**PLANNING AND ZONING ADVISORY BOARD AGENDA
ADVISORY/ COMMITTEE BOARD MEETING
Village Hall Council Chambers
226 Cypress Lane
Palm Springs, FL 33461
Tuesday, February 11, 2020
6:30 PM**

6.1 Ordinance No. 2020-04 - Land Use Plan Amendment (Large Scale) - 2085 South Congress Avenue and 3243 Lillian Road (Proposed Palm Springs Residences Residential Planned Development)

7.1 Resolution No. 2020-04: Residential Planned Development Site Plan (SPR20-2) and Two (2) Waivers, and Sign Variance (PSV20-01) - Palm Springs Residences - 2085 South Congress Avenue and 3243 Lillian Road (Quasi-Judicial Hearing)

SUBJECT: Large-Scale Land Use Amendment and Site Development Plan (Residential Planned Development Site Plan with Waivers) and Sign Variance - Palm Springs Residences – 2085 S Congress Ave and 3243 Lillian Rd

DATE:	07/19
DESIGNED BY:	JH
DRAWN BY:	RM
CHECKED BY:	JH
PROJECT:	1903-21
SHEET:	SP-1

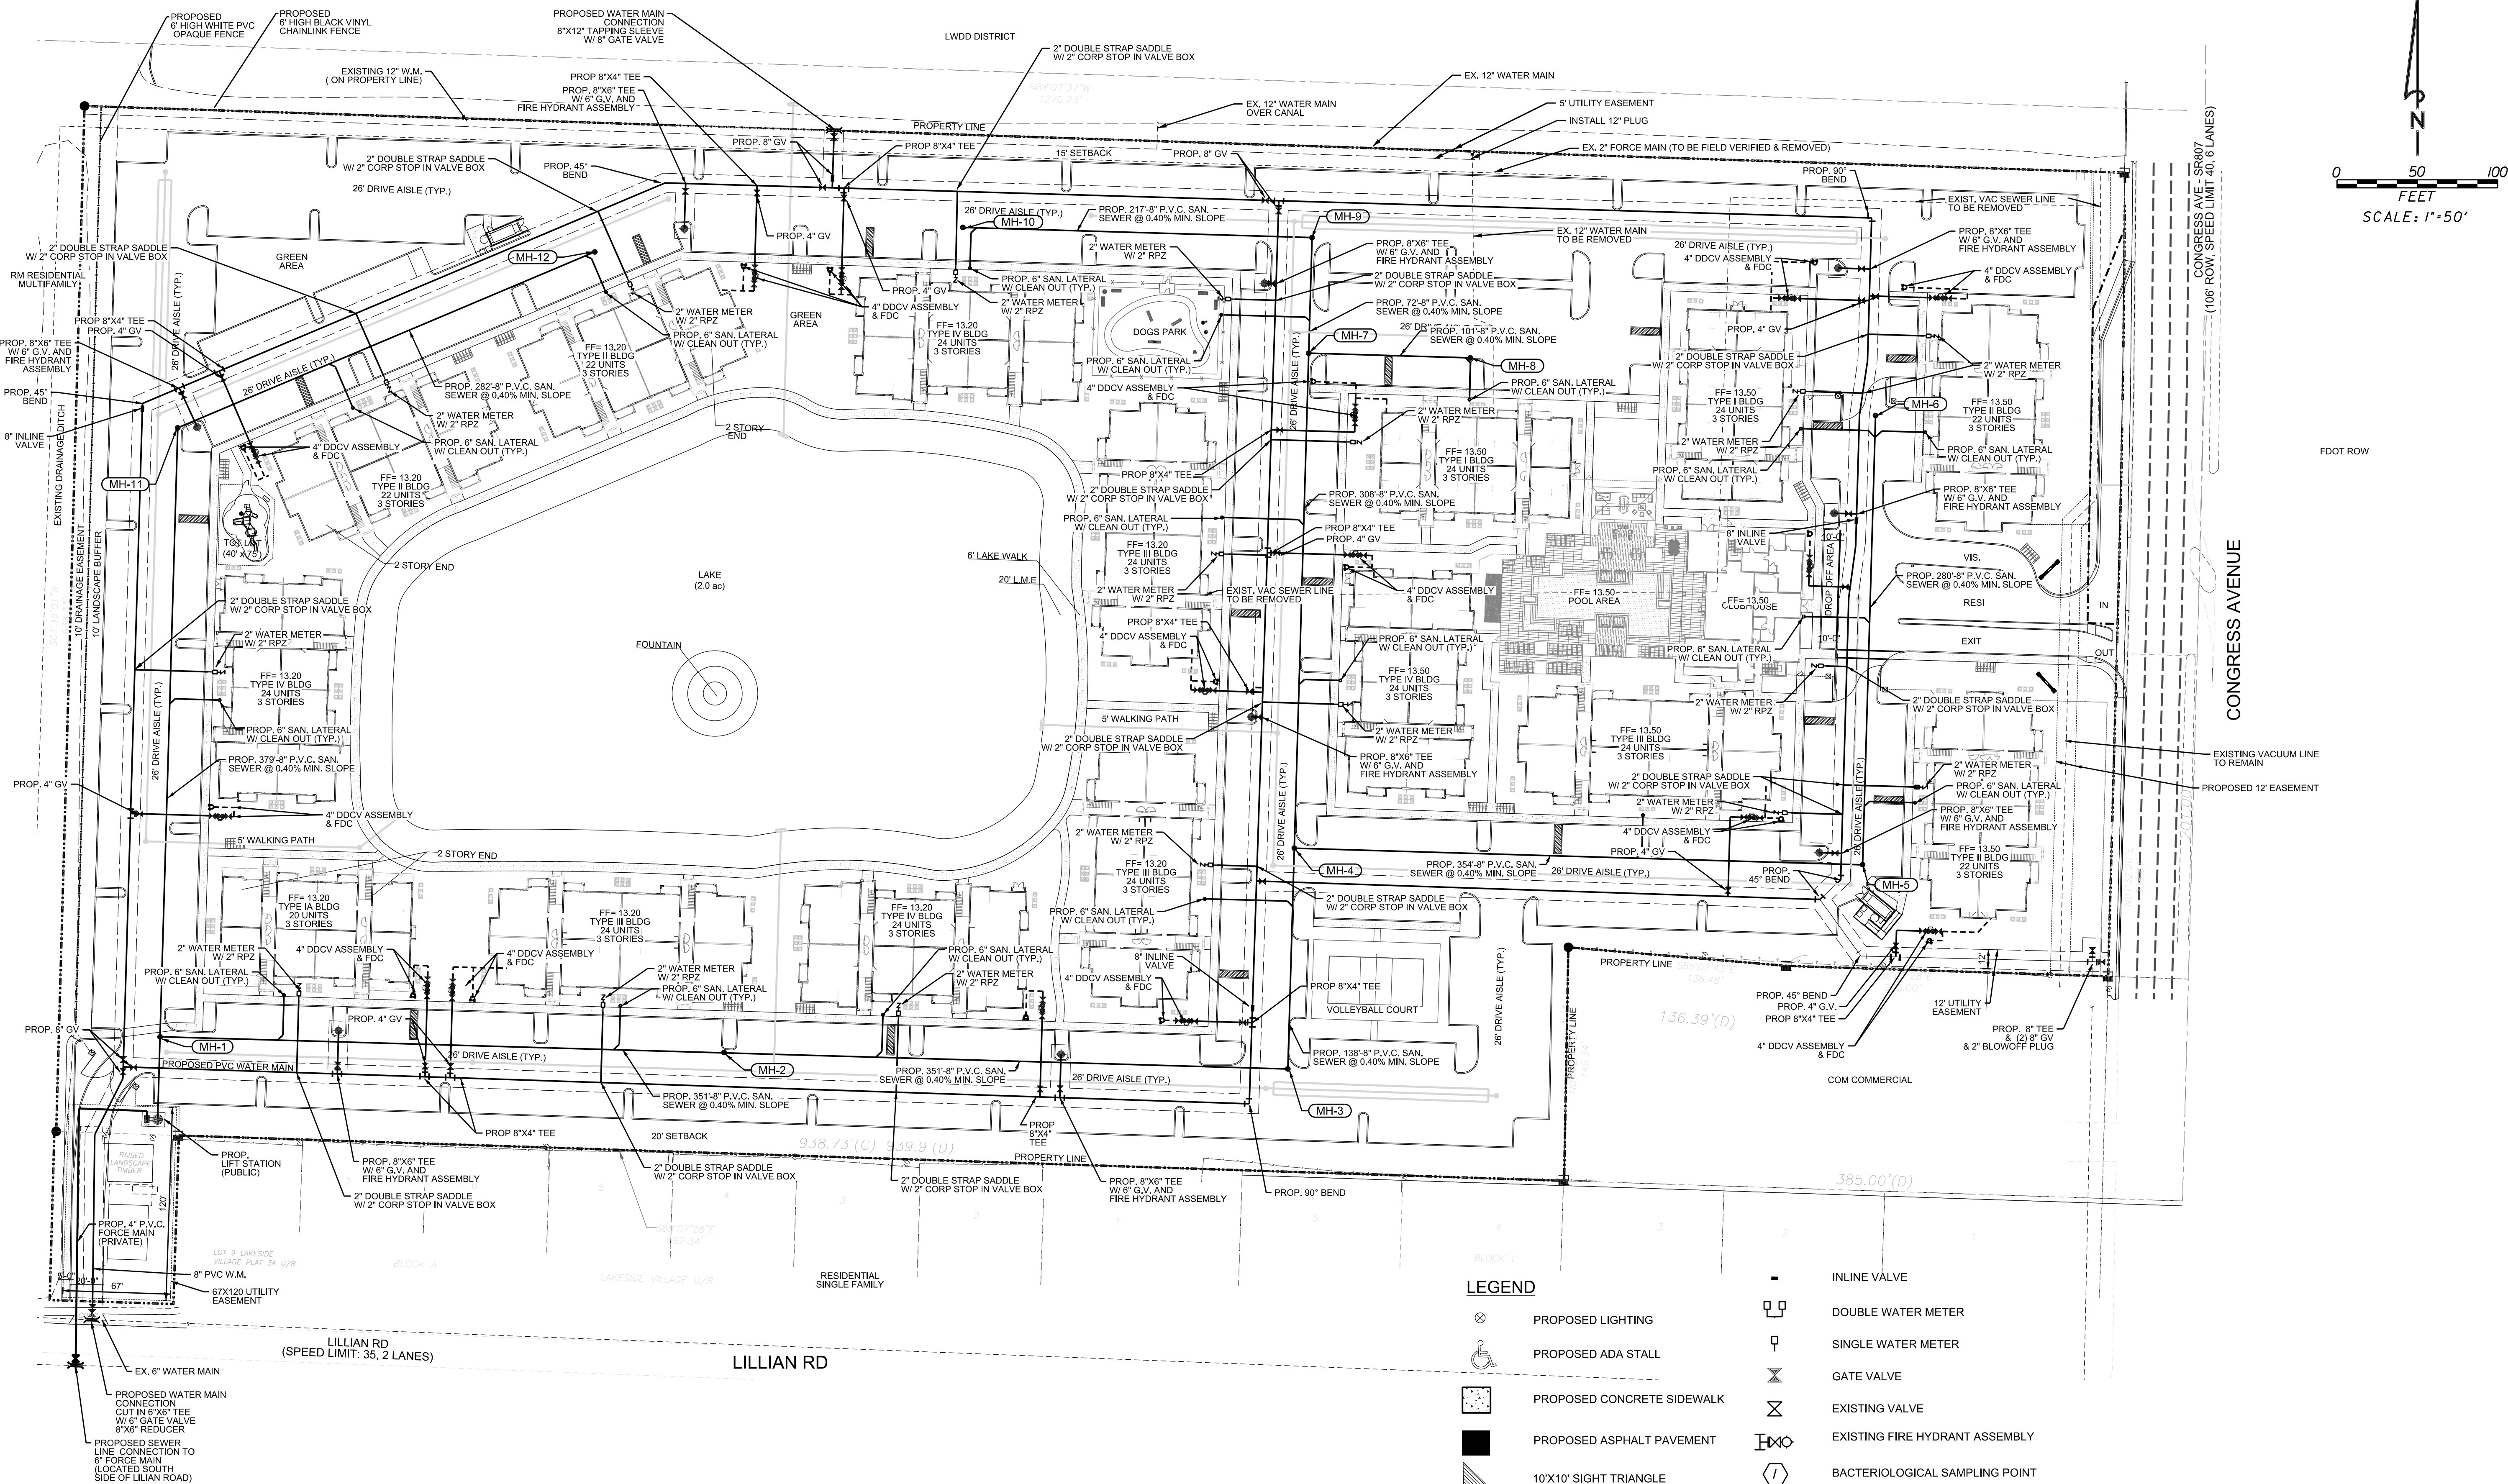
1. Per Site Plan (SP-1),
 - a. The proposed 6-ft white PVC opaque fence along the west property line runs up to the north property line, which blocks cross access to the drainage easement and utility easement. Provide a gate.
 - b. The ditch along the west property line runs to the south property line. The top of bank shall be relocated along the entire west property line as well as the 10-ft drainage easement.
2. Per Landscape Plans, Sheets L-211 & L-212, there shall be no trees within the 10-ft drainage easement along the west property line.

<u>Page</u>	<u>Comment</u>	<u>Code</u>
SP-1	The swing gates must both swing in the same direction. The truck modeling on sheet FT-1 shows the fire apparatus crossing the traffic divider line to make the turn to exit the site. This is not an acceptable turning radius. You will have to discuss your options when you submit the civil plans to the Water Officer.	
SP-1	A Knox key switch is required at each set of gates for fire dept. access.	
WS-1	The clubhouse must have an automatic fire sprinkler system installed.	PBC Fire Code 13.3.1.1.1(4)
